In the drawings

Please enter the corrections to Figures 2, 3 and 13 as shown on the "Replacement sheets" in the attached Appendix "A". Appendix "B" shows the "Annotated Marked-up copies of these sheets showing the changes made in red.

Remarks

FIG. 2

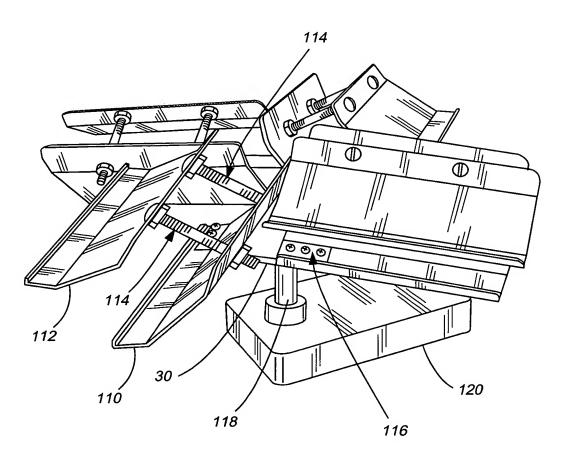
In particular, Figure 2 has been amended to show part numbers; which have been inserted on page 7 of the specification.

FIG.3

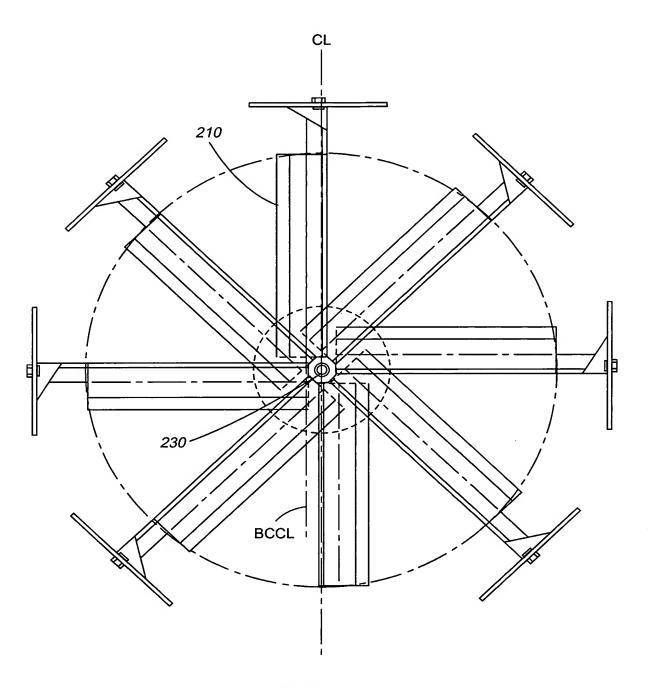
Figure 3 has been amended to show part numbers and center lines. A description has been inserted on page 8 of the specification.

FIG. 13

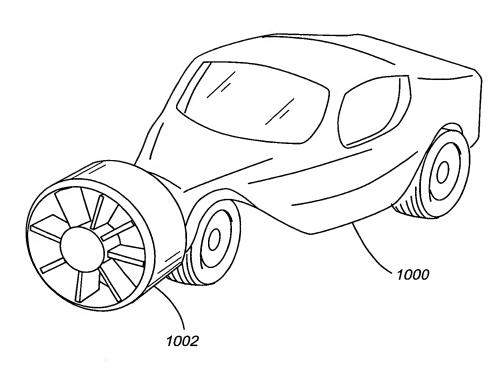
Figure 13 has been amended to show part numbers; which have been inserted on page 10 of the specification.
